WILLIAMSON COUNTY, TEXAS

CHANGE ORDER NUMBER: 1

**Bounds Street Improvements (Thrall)
Williamson County Project No. 21IFB15**

Change Order No. 1

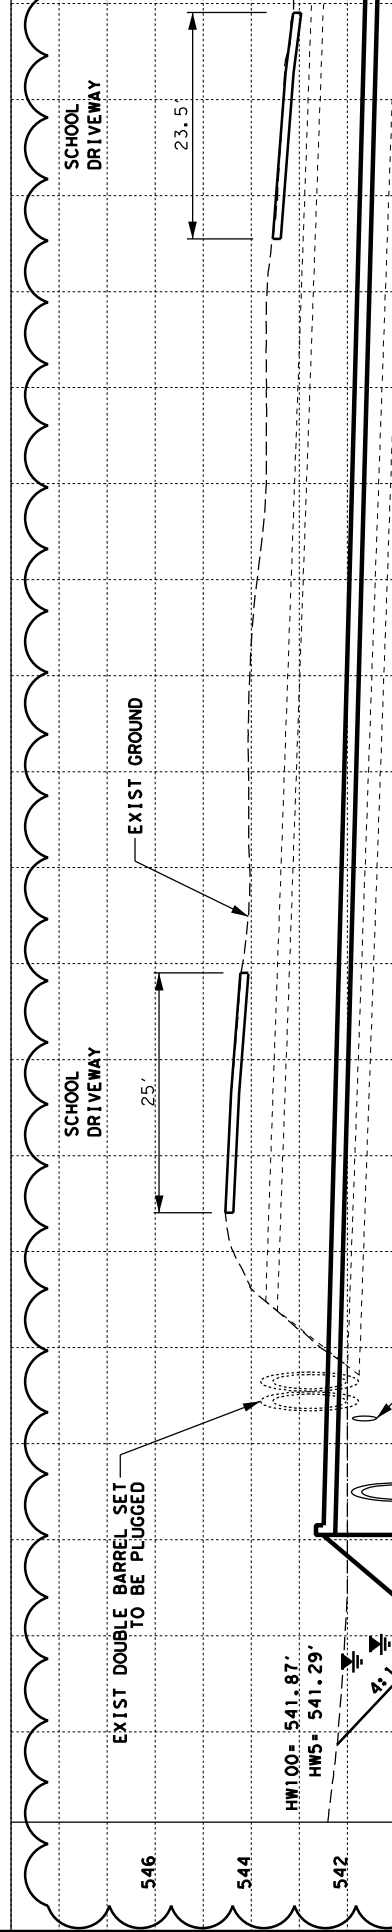
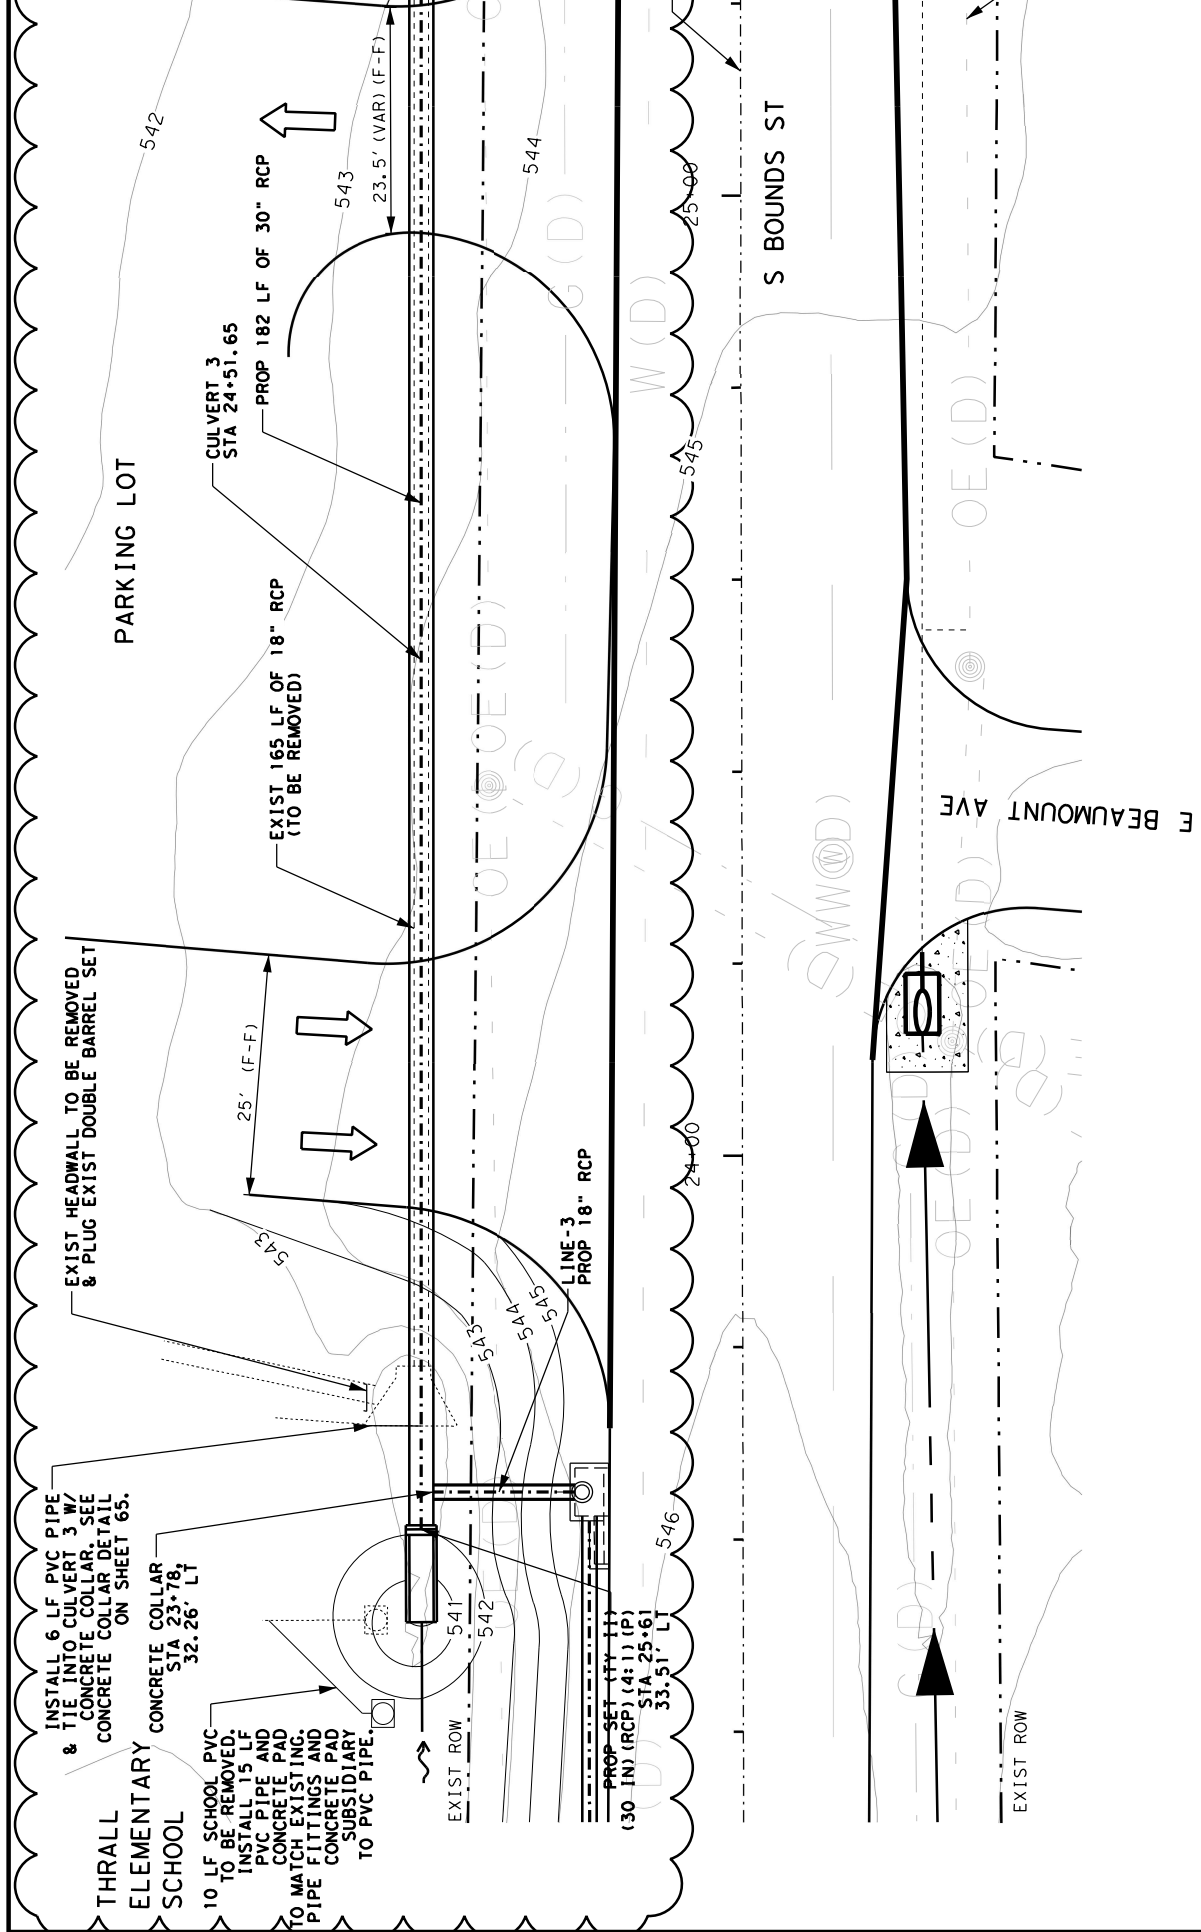
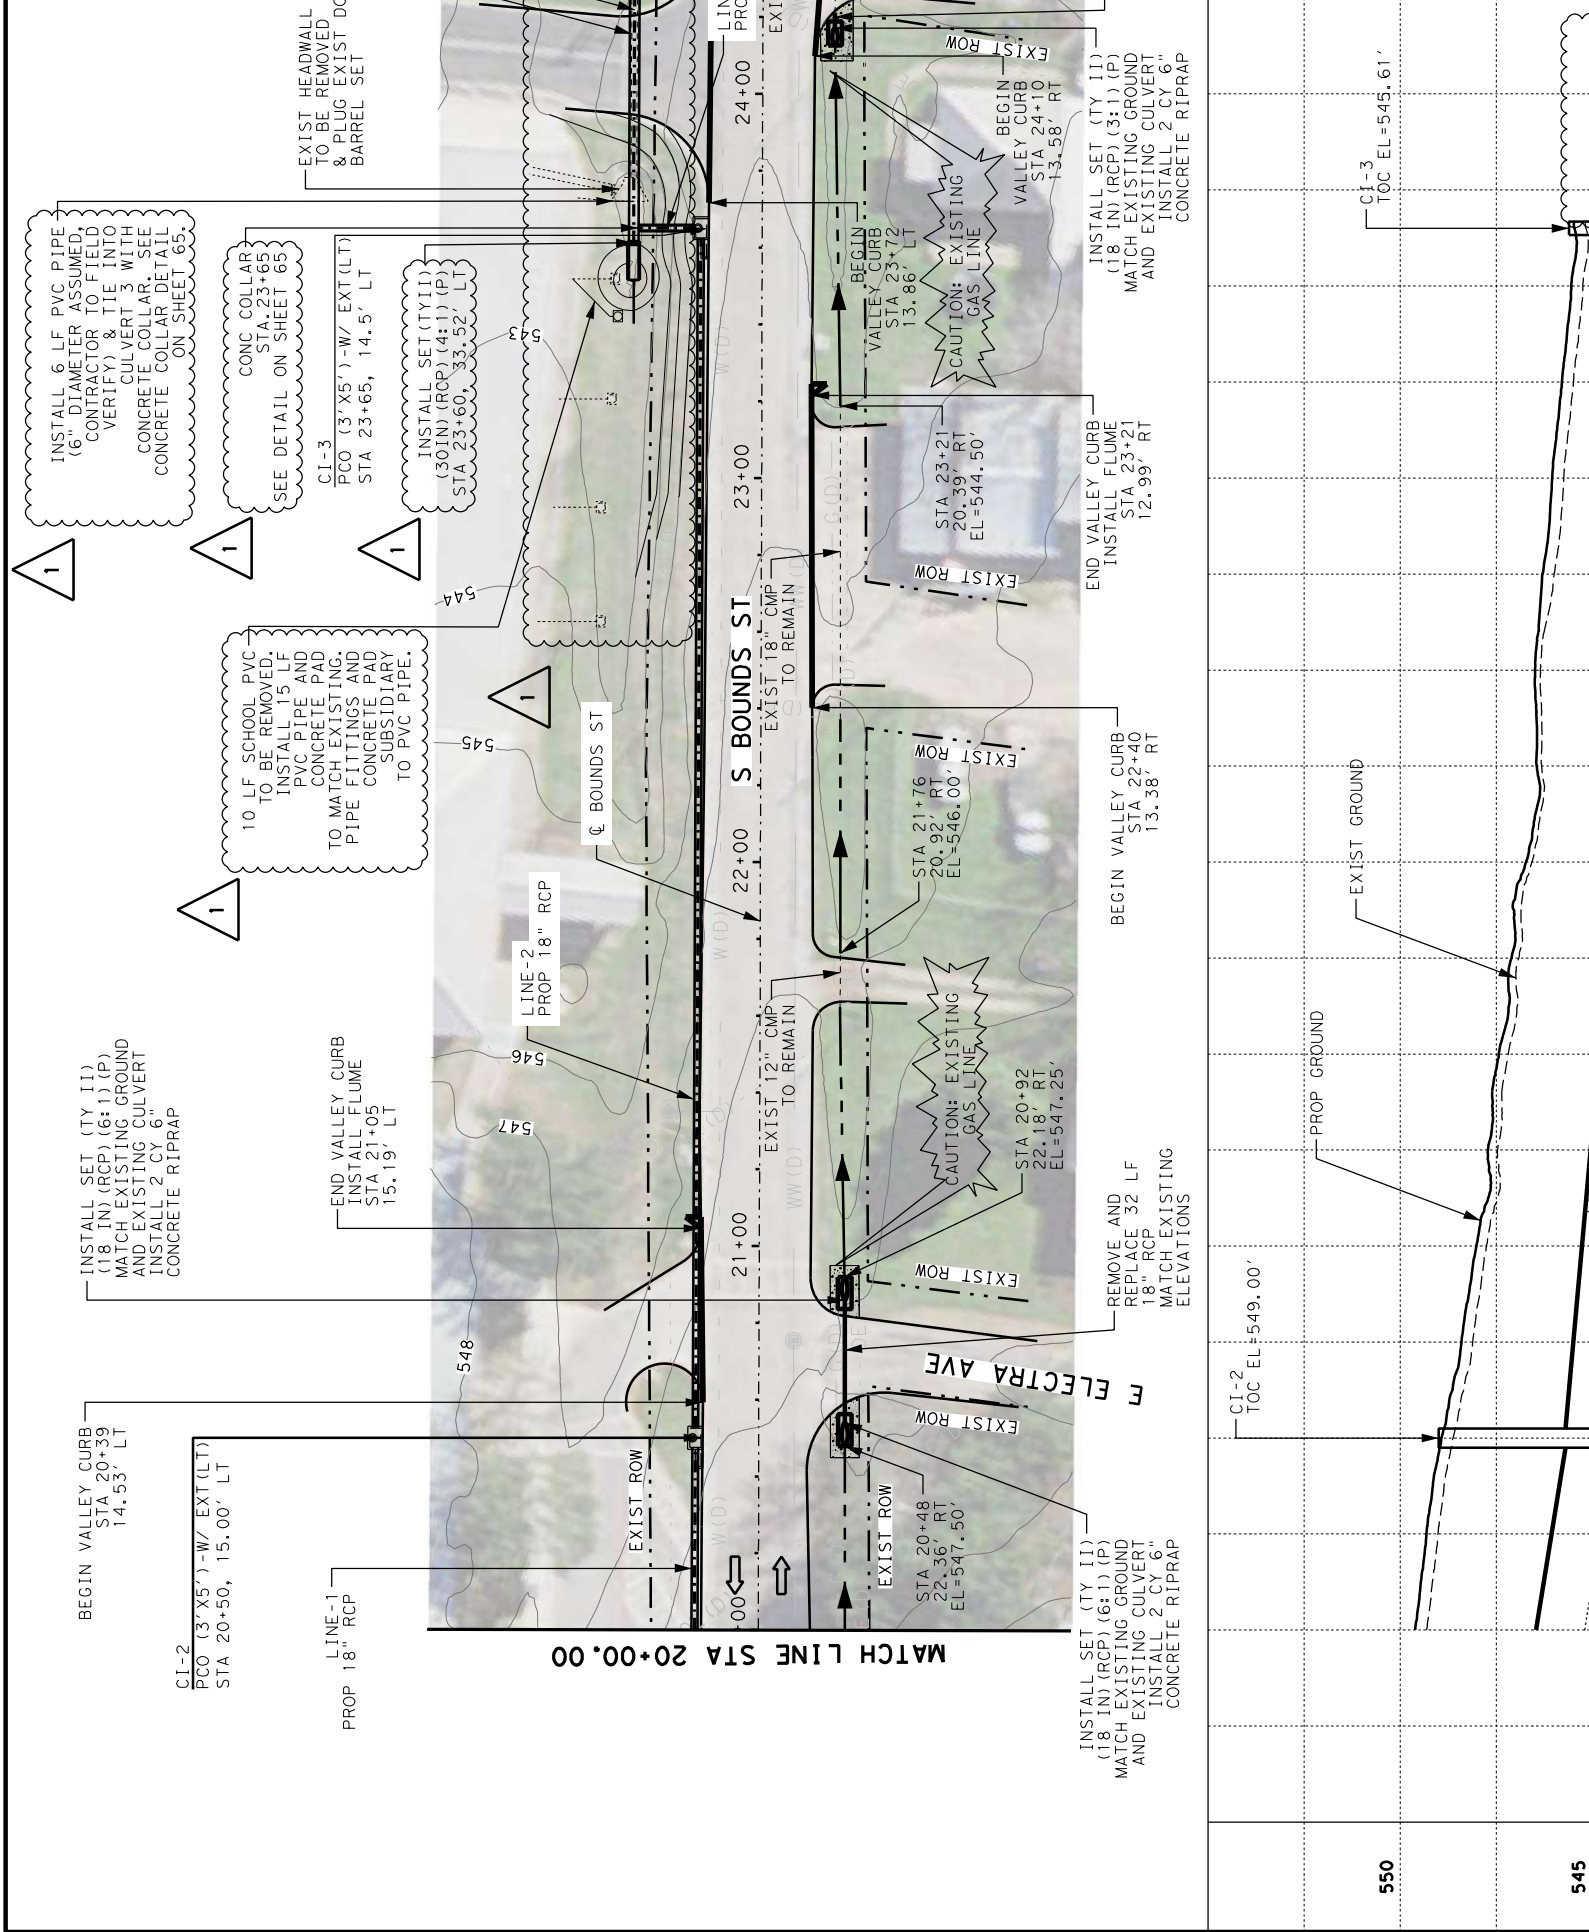
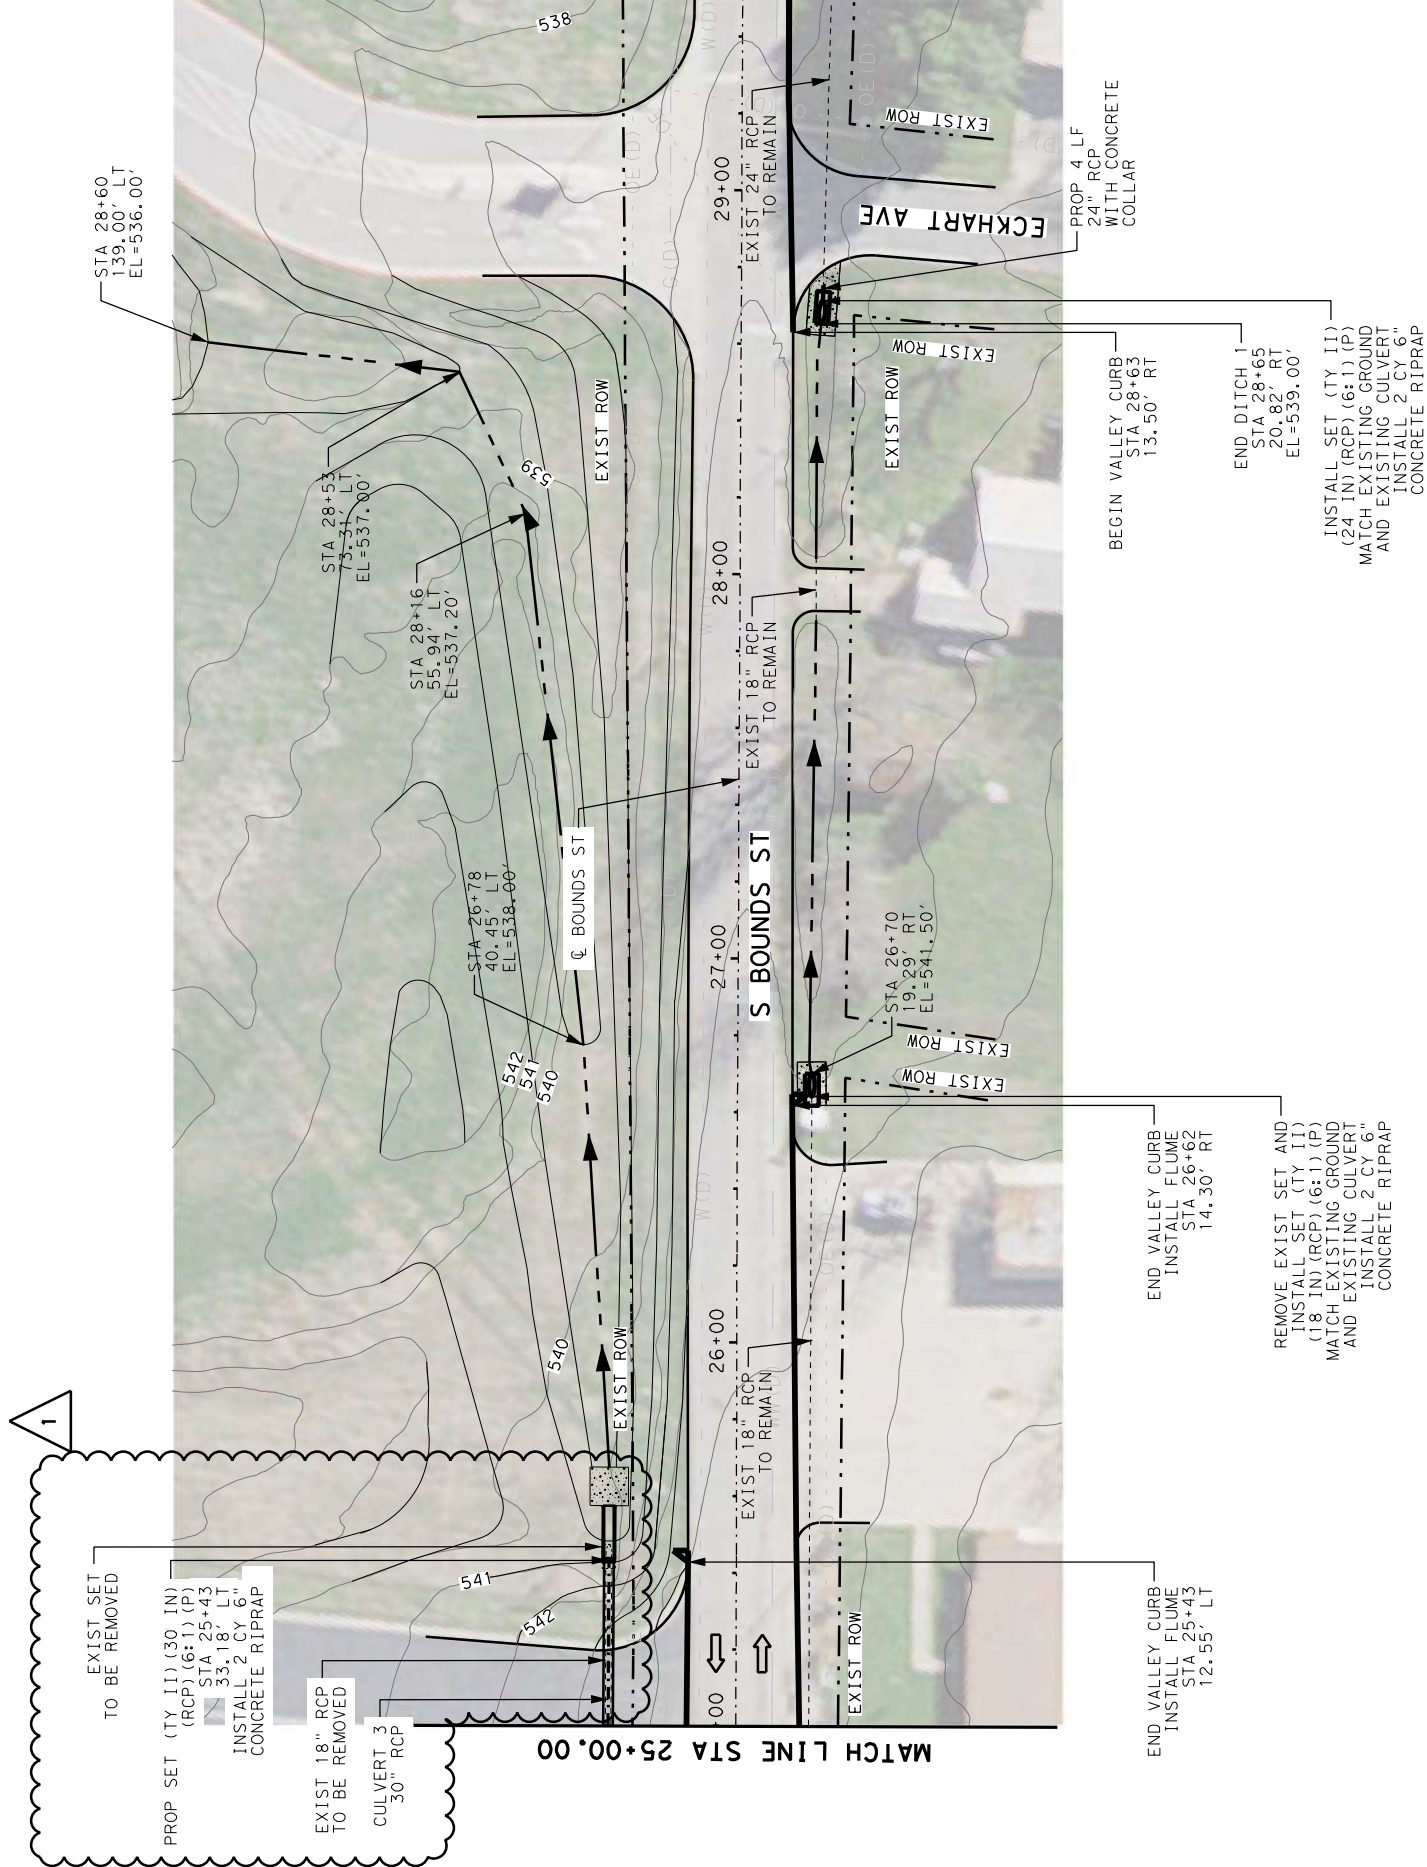
This Change Order revises the location of the drainage pipe and curb inlets to clear existing utilities and changes the curb inlets from PCO to PCU type inlets. PCO is an inlet with the box located behind the face of the curb. The conflict with the existing utility was located behind the curb. PCU is an inlet with the box located in front of the face of the curb. This Change Order also revises the pipe connection between the curb inlet and the pipe under the driveway and increases the quantity of pavement repair due to the current condition of the pavement.

ITEM	DESCRIPTION	QTY	UNIT
401-6001	FLOWABLE BACKFILL	150	CY
465-6030	INLET (COMP)(PCU)(3FT)(LEFT)	3	EA
3076-WC01	BLADE LAY TY B HMAC OVER PIPE	10	TON
